# Synthetic Review Drawing Stub

<b>Part</b>	Lamella pusher head side plate
<b>Revision</b>	B
<b>Pilot</b>	SOMIC
<b>Material</b>	Al 7075-T6

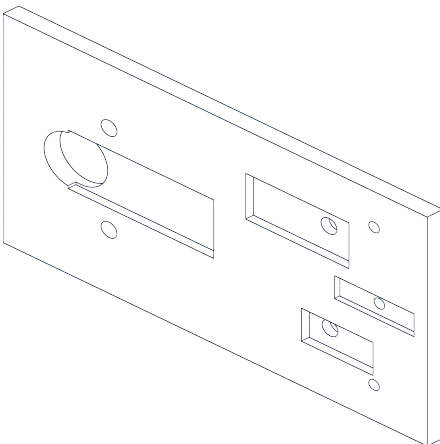
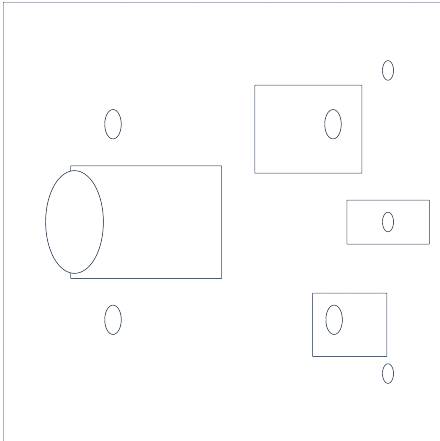
- Move one guide hole by 0.8 mm to correct alignment.
- Add one extra weight-reduction pocket without changing the outer plate envelope.
- Preserve the main bearing seat so the revision reads as a trimmed adjustment rather than a new plate.
